Addendum #2

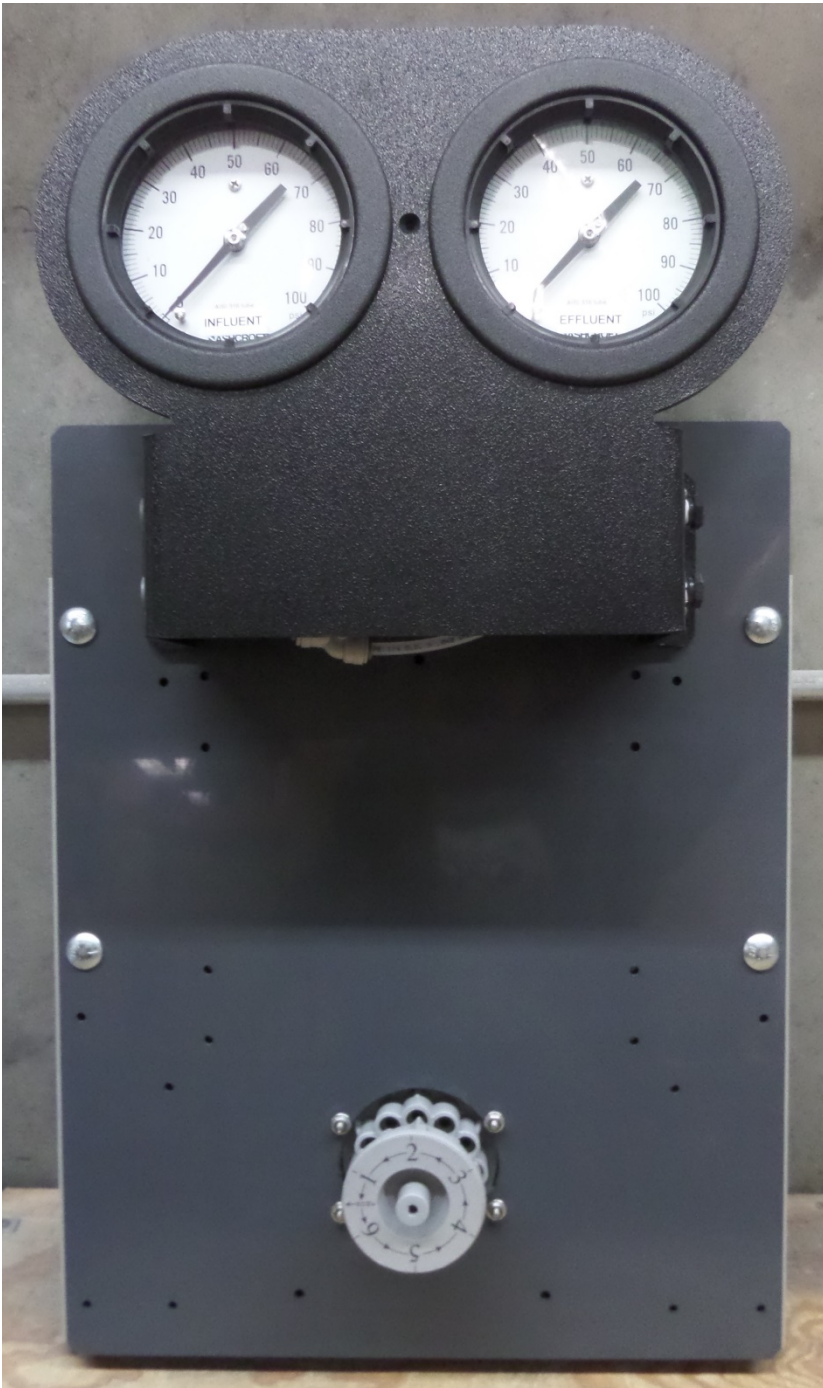
- 1) The drawings refer to a fully automated filter system. The specs call out for a BECS backwash control system. This system is not a stand-alone system and needs a BECS 7 chemical controller to operate the system. The chemical controller is listed to remain. Please clarify if the intent is to replace the chemical controller or use a different filter control system.
 - a) It has been identified that the controller on-site does not have the capability to control the specified filter system. Please include the attached Semi-Automatic control system in your bid.

Semi-automatic
backwash controller for
Eko³ filter system with
priority valve; includes
pressure gauges and dial
valve
